Access Compliance Report Public Rights-of-Way (Curb Ramps)

Intersection ID: 10040568 Main Street: W ARROWOOD RD **Cross Street: N/A** Location: SE ADA ID: BEF45BD982A3 Ramp Type: PerpDiag Initial Pass/Fail: Fail **Overall Compliance: No Severity Score:** 12.5

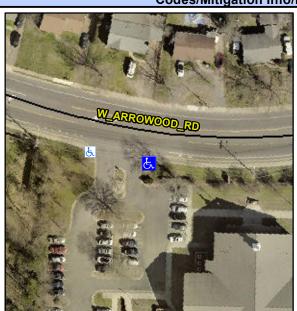
W ARROWOOD RD Street 1 Name Stop Condition-Street 2 None Street 2 Name **ENTRANCE** Stop Condition-Street 1 None Possible Solutions: Remove & Replace Curb Ramp With Two New Directional Ramps or Equivalent. Surveyor Notes: N/A PROW/ADA: Not Found, R304.2.2

Field Measurements/Component Compliance							
	Compl	iance Description	Data	Comp	liance I	Description	Data
	N/A	Ramp Length (in)	61.0	No	Ramp	Slope (%)	9.0
	Yes	Ramp Width (in)	48.0	Yes	Ramp 2	XSlope (%)	1.8
	N/A	Flare Type LT	N/A	N/A	Flare T	ype RT	N/A
	N/A	Flare Slope LT (%)	N/A	N/A	Flare S	Slope RT (%)	N/A
	N/A	Flare Traversable LT?	N/A	N/A	Flare T	raversable RT?	N/A
	N/A	Landing Length (in)	N/A	N/A	DWS F	Provided?	N/A
	N/A	Landing Width (in)	N/A	N/A	DWS C	Contrast?	N/A
	N/A	Landing Slope (%)	N/A	N/A	DWS L	ength (in)	N/A
	N/A	Landing X Slope (%)	N/A	N/A	DWS F	Full Width?	N/A
	N/A	Landing Curb? (Y/N)	N/A	N/A	DWS C	Offset (in)	N/A
	N/A	Shared Landing?	N/A				
	N/A	Gutter Ponding?	N/A	N/A	Gutter	Slope (%)	N/A
	N/A	Gutter Lip Ht (in)	N/A	N/A	Gutter	X Slope (%)	N/A
	N/A	Painted X Walk1?	No	N/A	Painted	d X Walk2?	No
		X Walk 1 Direction	To N		X Walk	2 Direction	To W
	N/A	X Walk 1 Width (in)	N/A	N/A	X Walk	2 Width (in)	N/A
